**Wellington Solar Farm Modification Application (SSD 8573 Mod 1)
Amendment to Modification Application**

I am writing to formally amend the modification application currently being assessed by the Department of Planning, Industry and Environment for the Wellington Solar Farm (SSD 8573 Mod 1). The modification application now seeks approval for an additional area to accommodate the fill and batter required to support the Wellington Substation bench extension. Refer to the attached drawings, Annexure A.

Figure 1: Updated substation expansion footprint

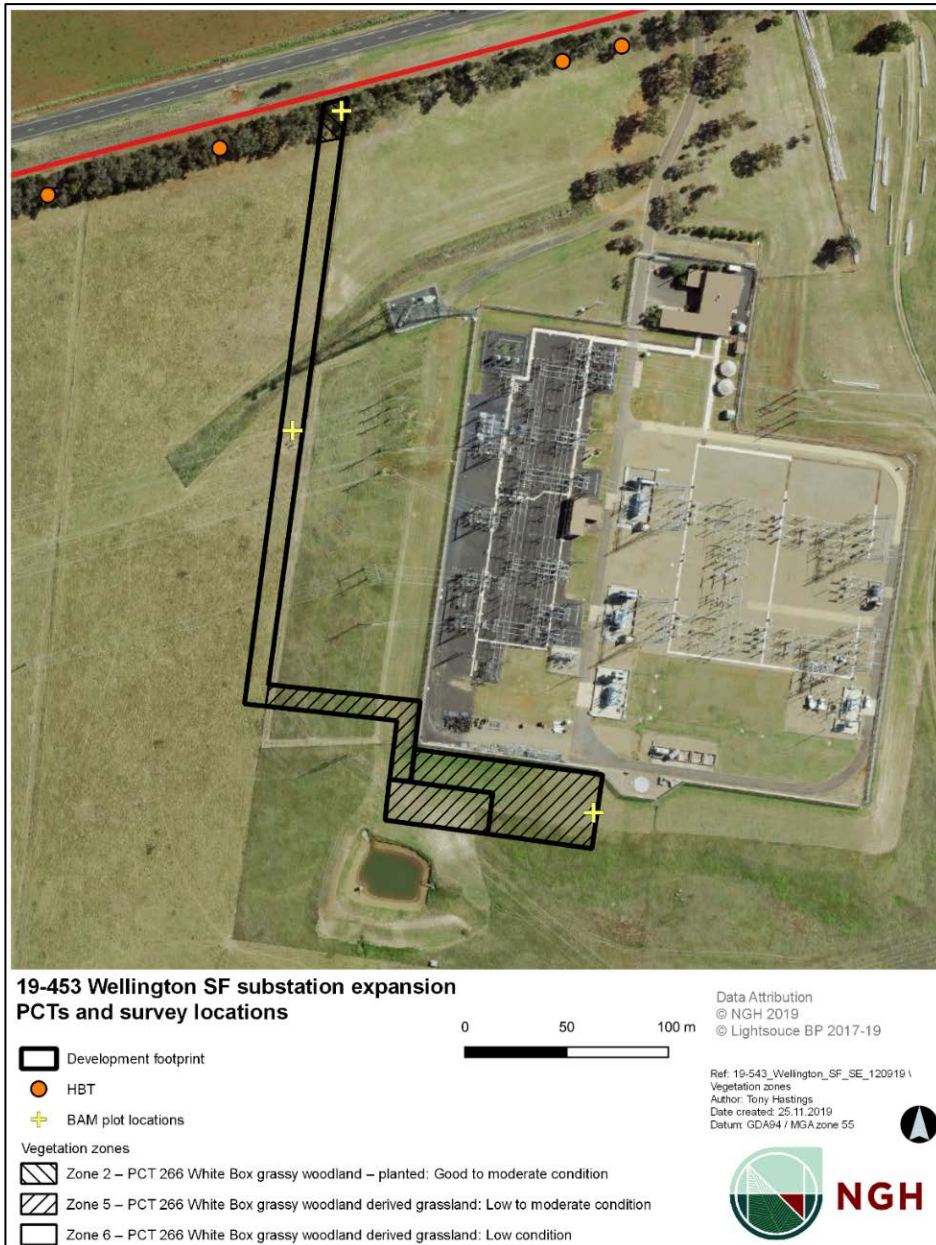
The additional area for the batter is comprised of 0.1 ha of Vegetation Zone 5 (PCT 266) – White Box grassy woodland derived grassland (moderate to low condition). The location of the additional area is within the project site previously surveyed by NGH, hence Plant Community Types (PCTs) and BAM plot data are available for this area.

With the inclusion of this additional area, the modification application would require 0.78 ha of ground disturbance, comprised of the following vegetation communities:

- Vegetation Zone 2 (PCT 266) - White Box grassy woodland – planted (moderate to good condition) - 0.02 hectares (ha)
- Vegetation Zone 5 (PCT 266) - White Box grassy woodland derived grassland (moderate to low condition) - 0.46 ha
- Vegetation Zone 6 (PCT 266) - White Box grassy woodland derived grassland (low condition) – 0.30 ha

Re-running the Biodiversity Assessment Method (BAM) calculator on 21 November 2019, for this small change in area for Zone 5 did not require any additional plot data; the minimum plot requirements of the BAM have been met. Further, no habitat features would be impacted. Refer to Figure 1 for expanded fill area and location of existing plots and habitat features.

© TransGrid		
WELLINGTON 330KV SUBSTATION EARTHWORKS - BENCH EARTHWORKS - BENCH BULK EARTHWORKS LAYOUT		
A1	WL1858295	00
PREFIX	NUMBER	SHEET
INDEX	CLASS	AMDT
		02-20

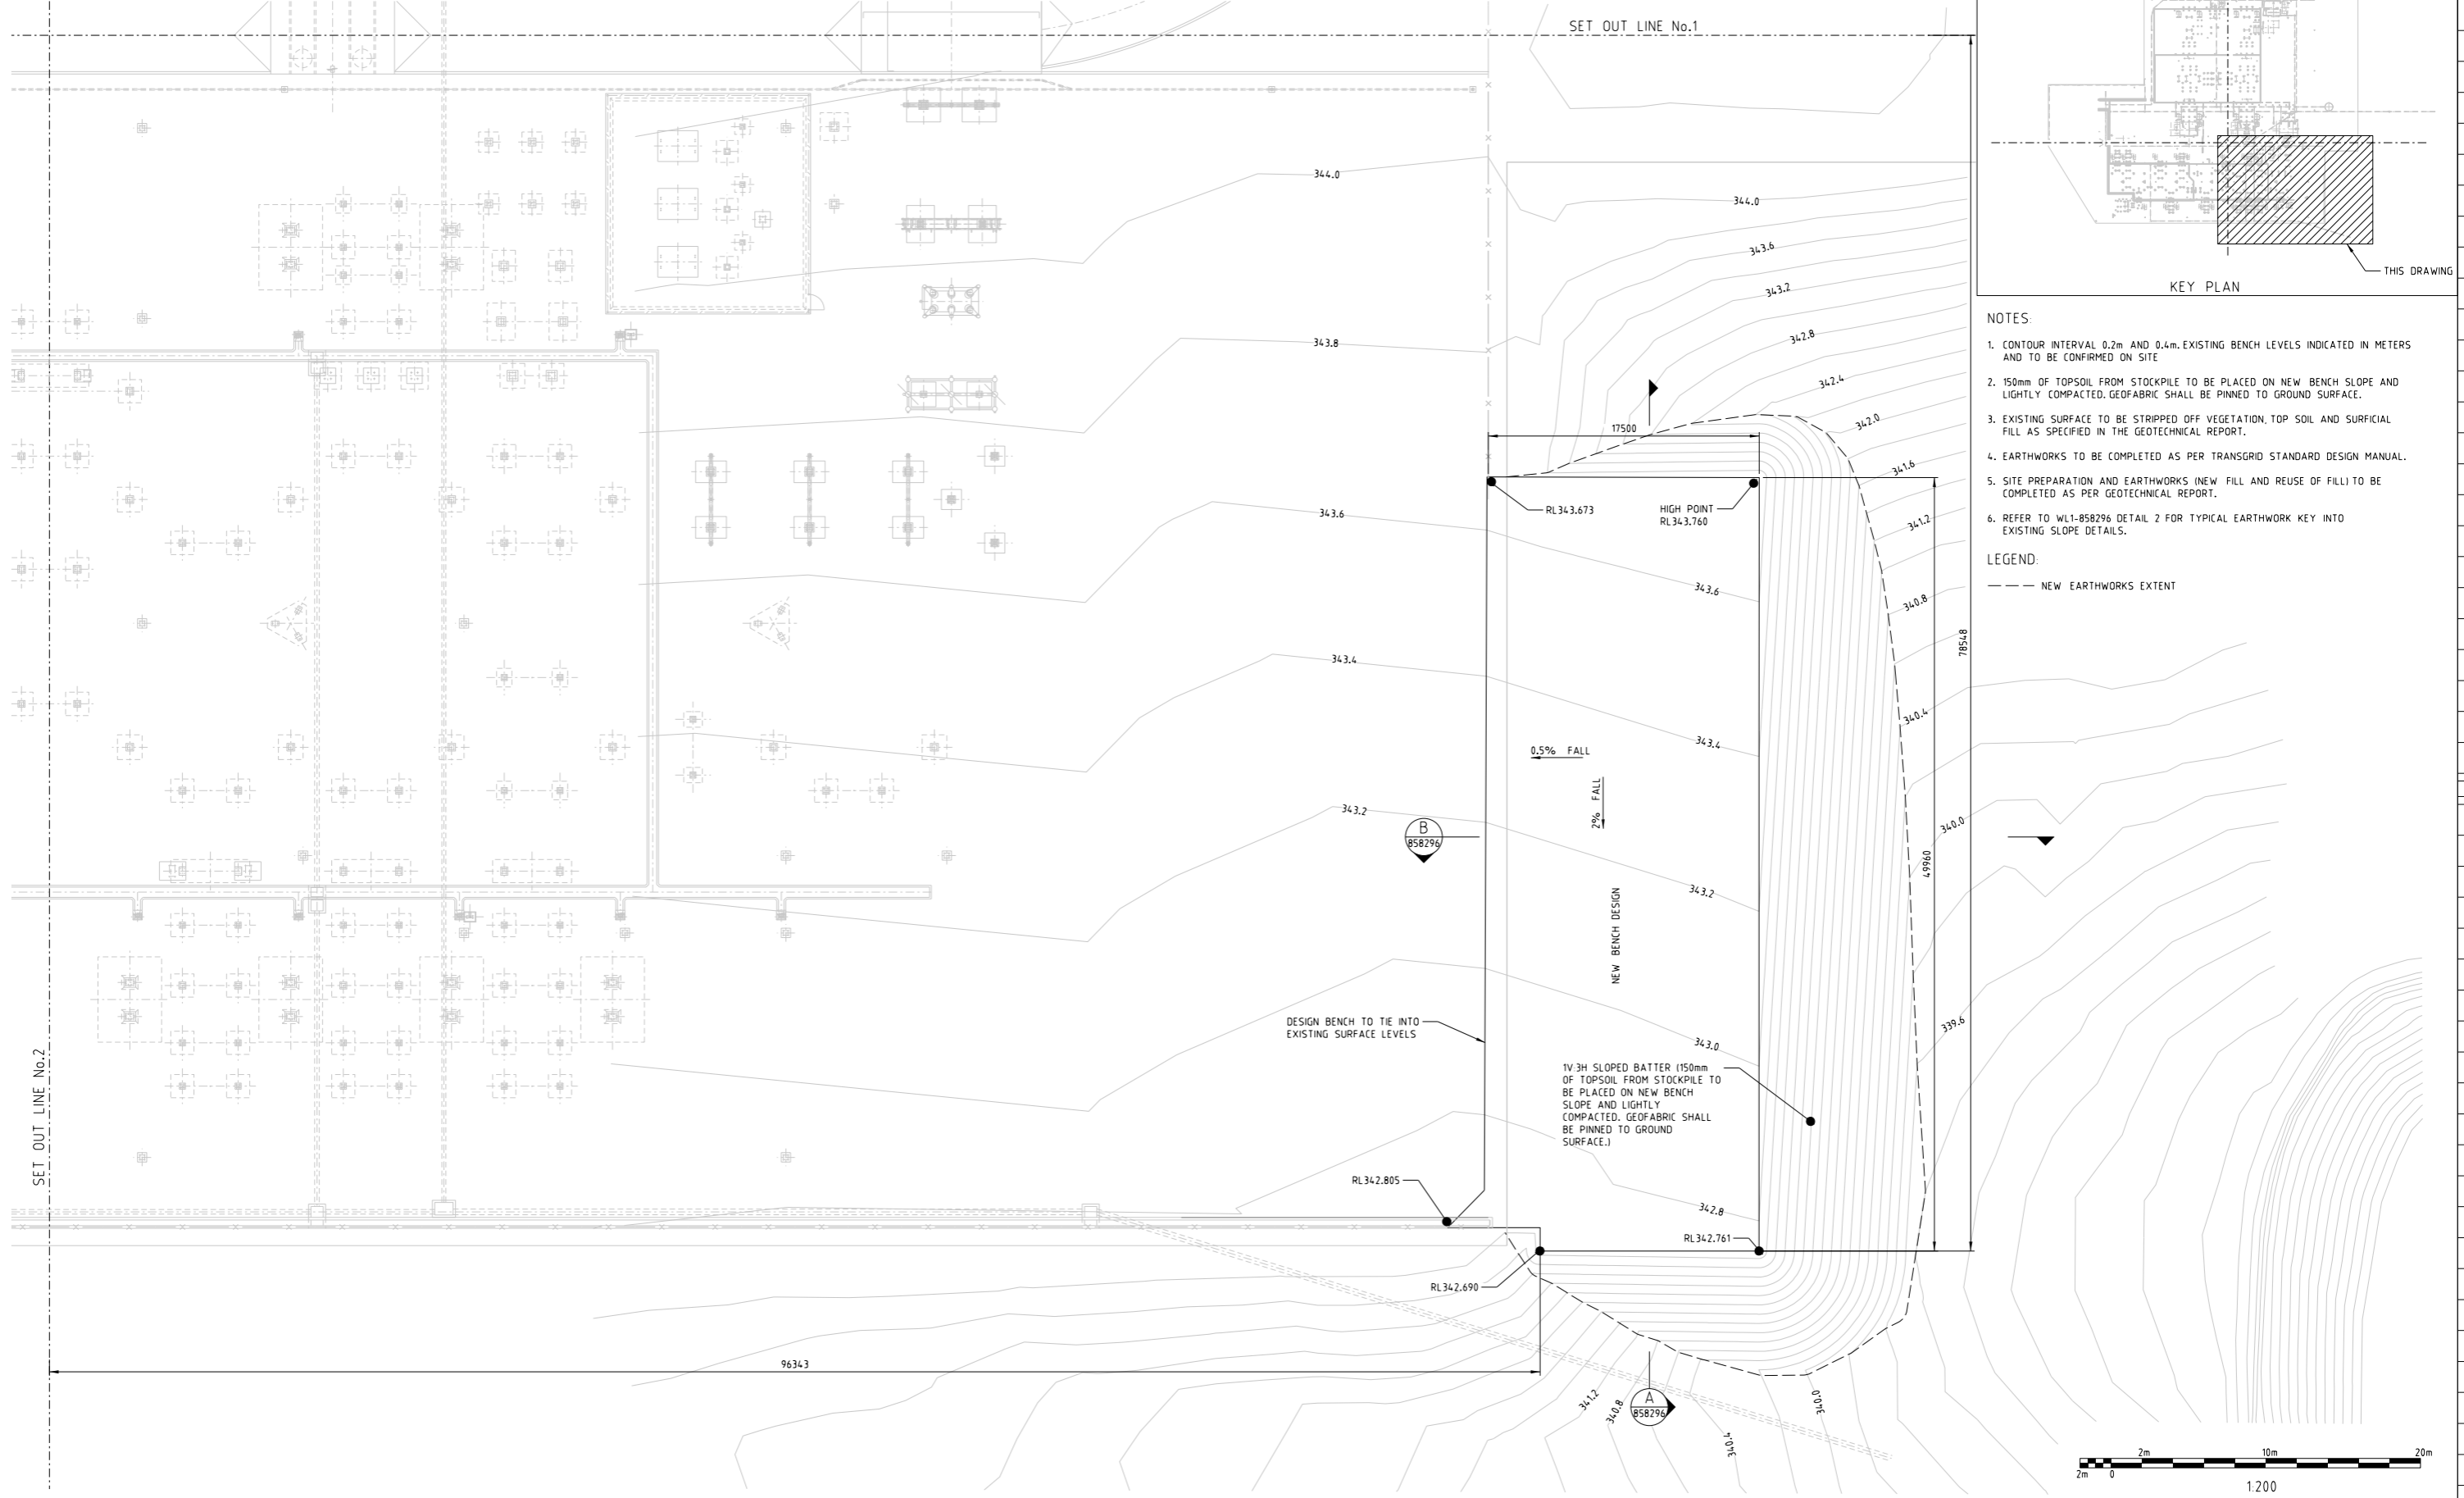
The additional area equates to 0.1 hectares (ha). We have estimated that approximately 700 cubic metres of fill would be required for the batter; 140 cubic metres of this would be road base.

Figure 1. Proposed modification.

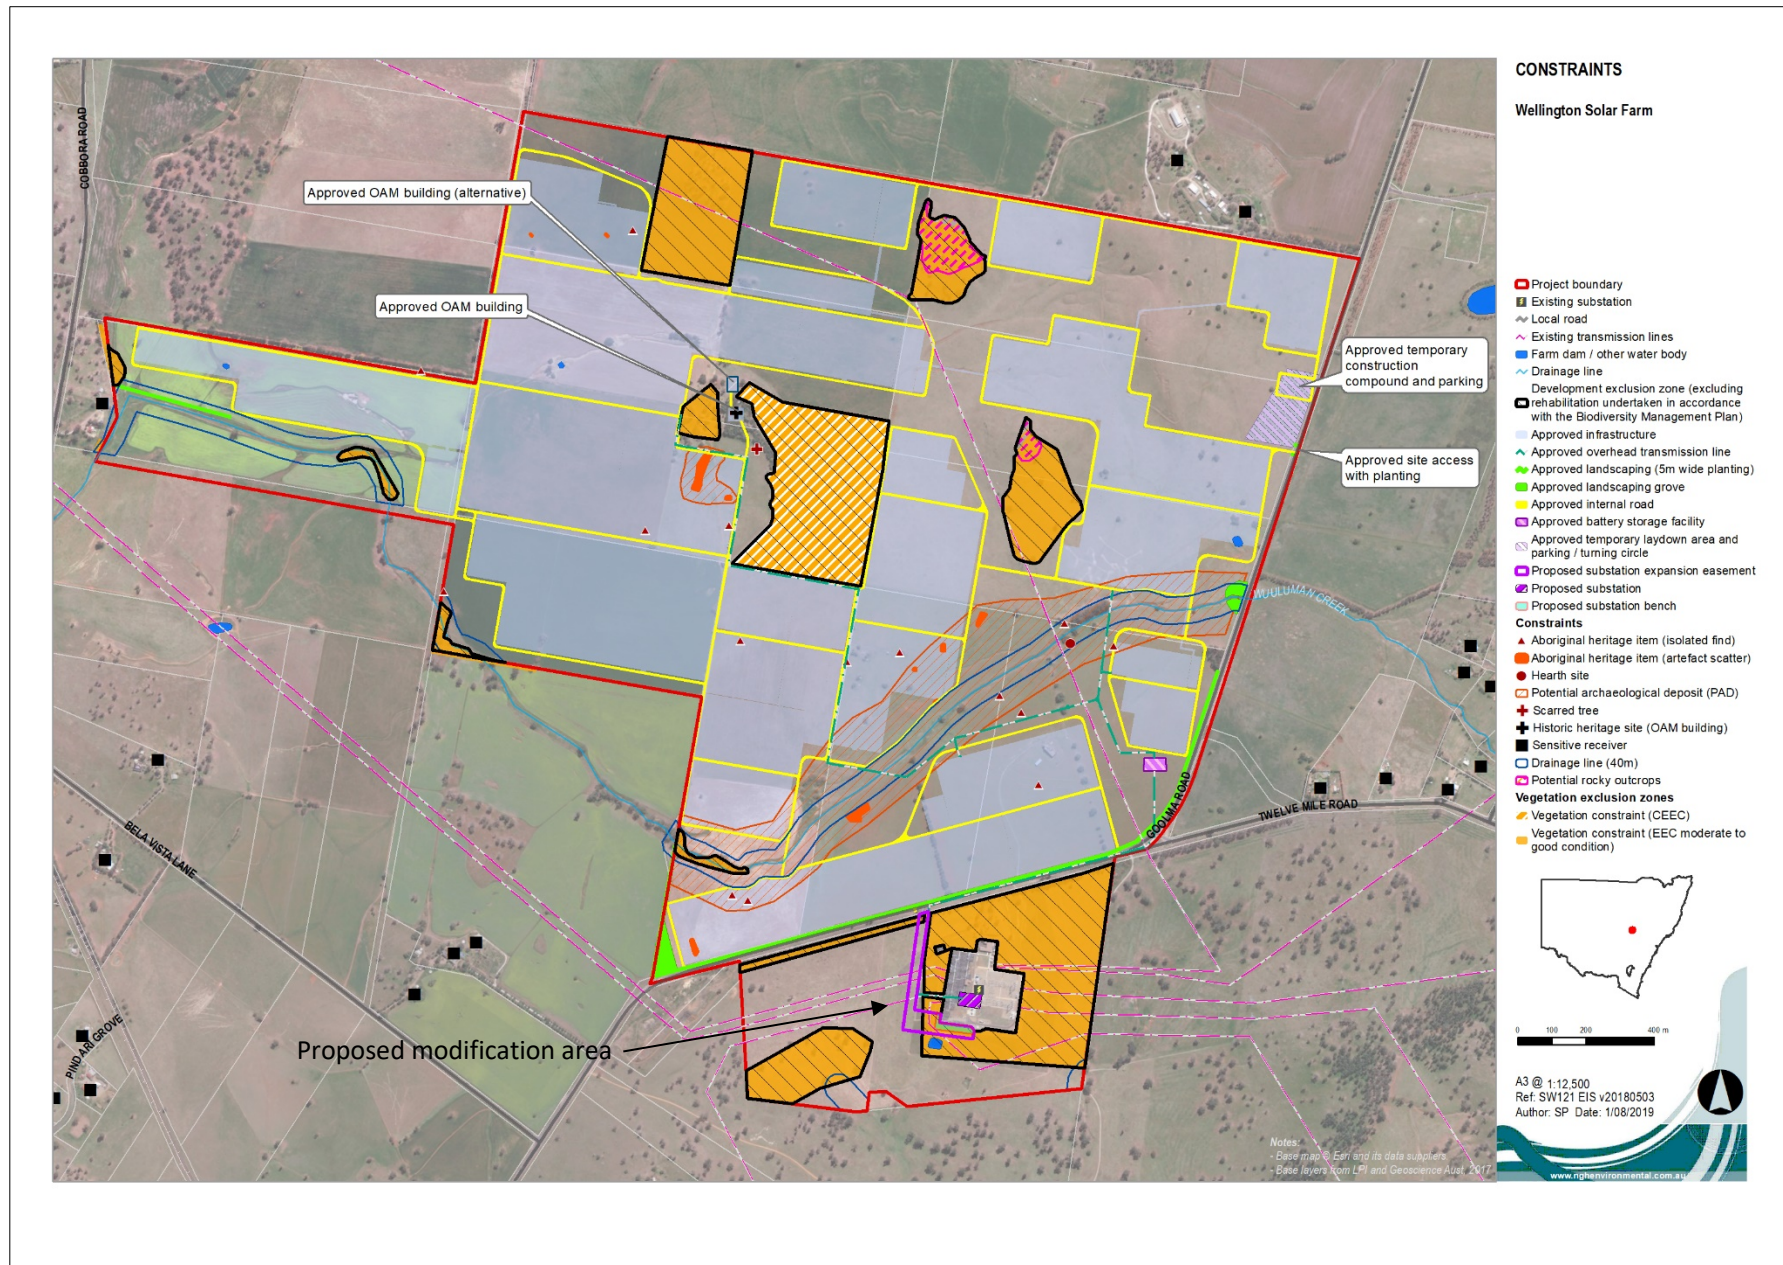
Recently NGH Environmental was informed that a modification to the development footprint is required to connect the solar farm to the existing adjacent substation. The modification will impact approximately 1.8 hectares as shown in Figure 1 with the proposed transmission line roughly following an existing fence line before connecting to the south-western side of the substation.
